RE: Daniels South Comprehensive Plan Amendments
CPA2021-00017 & CPA2021-00018 – 1st Insufficiency Response

The purpose of this letter is to provide a response to the Lee County Department of Community Development's review comments dated January 10, 2022, for the Comprehensive Plan Amendment applications referenced above. We appreciate the coordination and assistance from Staff over the past few months related to this application.

Daniels Parkway South
Comprehensive Plan Amendments
CPA2021-00017 & CPA2021-00018

FIRM MAP

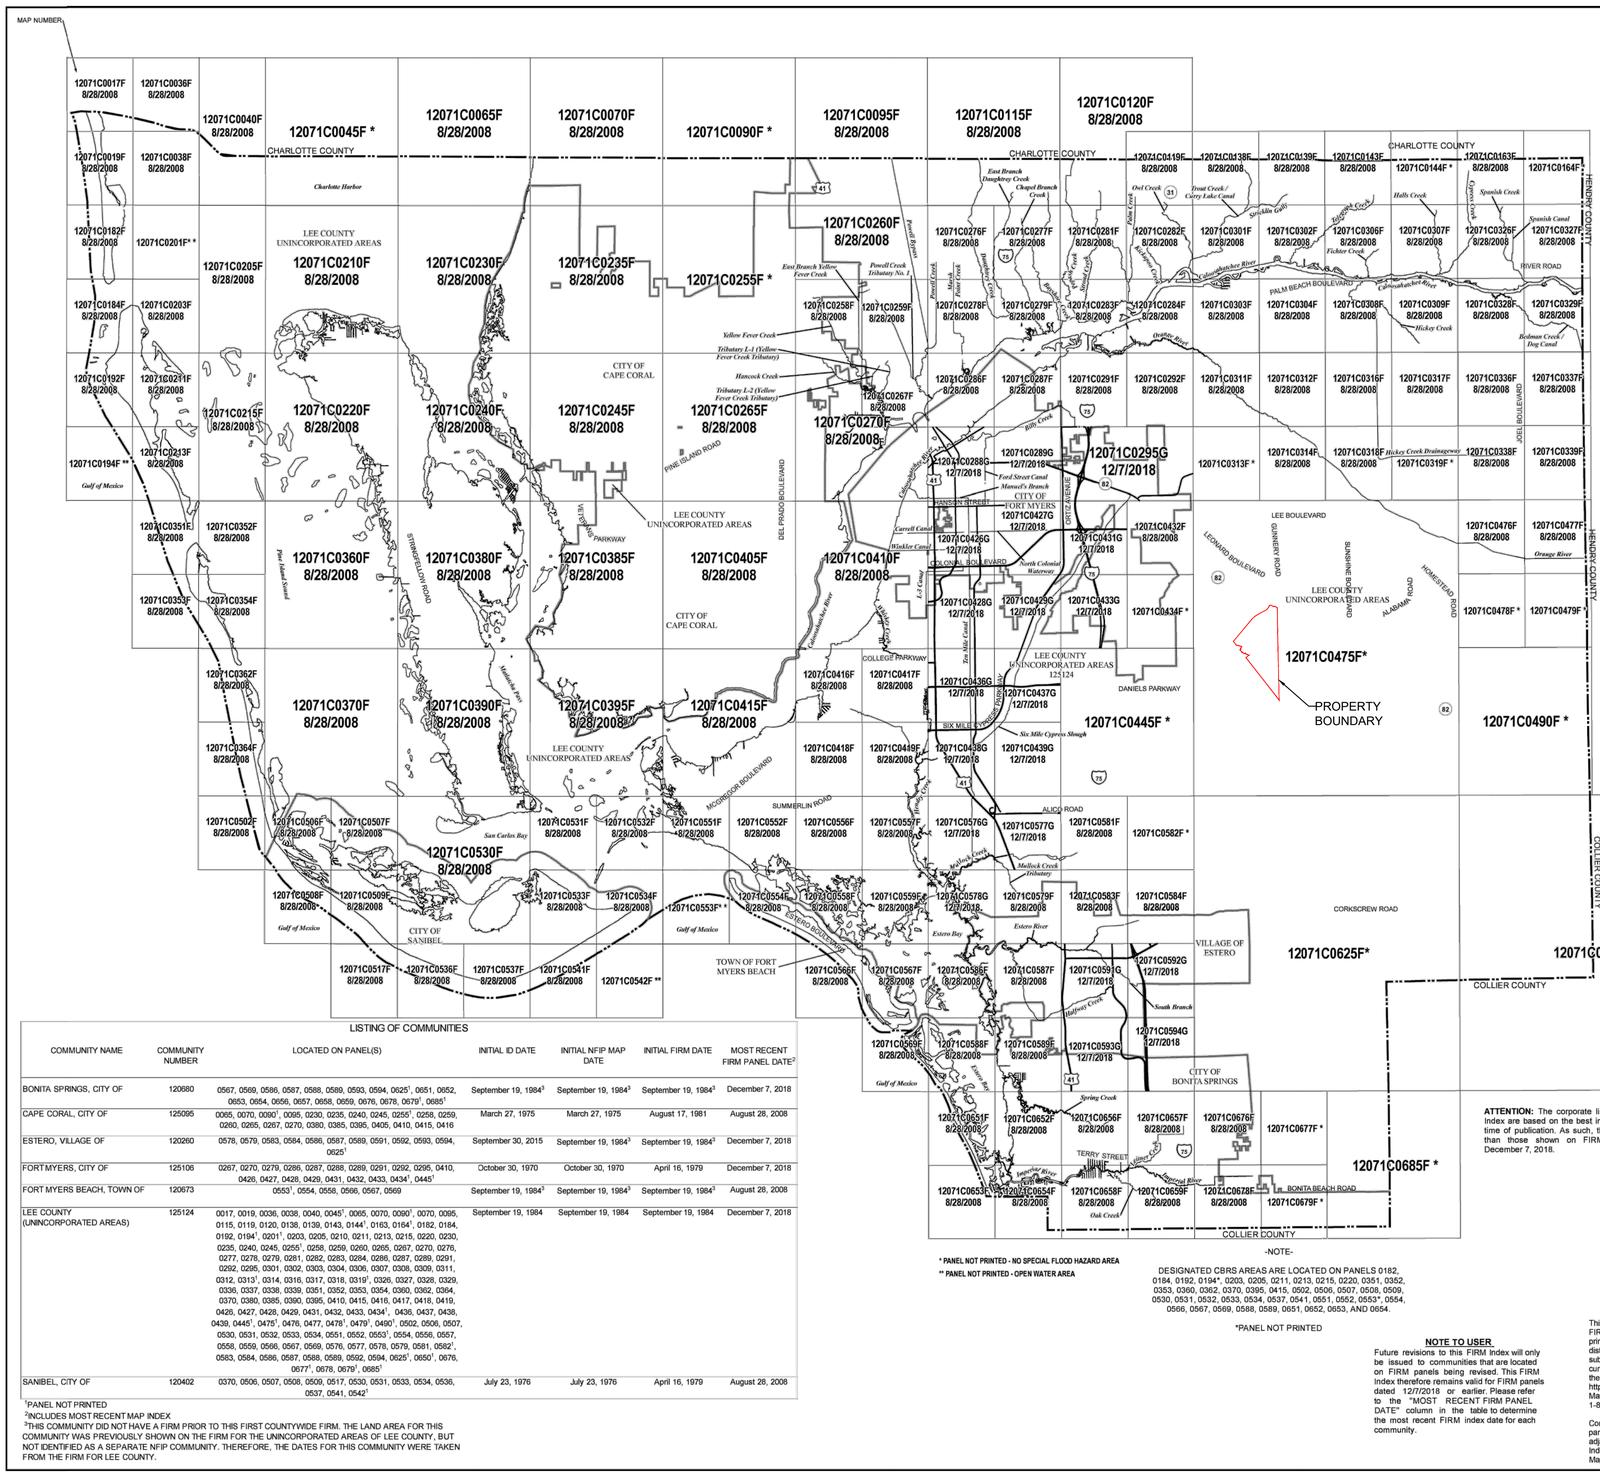
b) Provide a map delineating the property boundaries on the most recent Flood Insurance Rate Map. (CPA2021-00018).

RESPONSE: Please see the attached Flood Insurance Rate Map included in Attachment 3.
